# **Mitchell Field Boating Access Improvements**

MaineDOT WIN 23082.00 & 23472.00

# Addendum #4

September 4, 2025

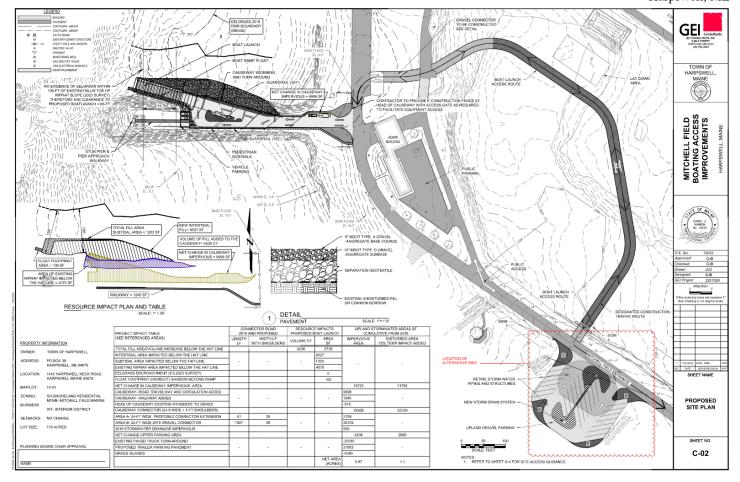
Amendment #3, answer #7 references a detail on Sheet C-01 which does not exist. There is a detail on sheet C-02, but it does not show the HMA. Could you please clarify?

The paved roadway detail is Detail 1 on Sheet C-04. Answer #7 in Addendum #3 should be corrected to reference Sheet C-04.
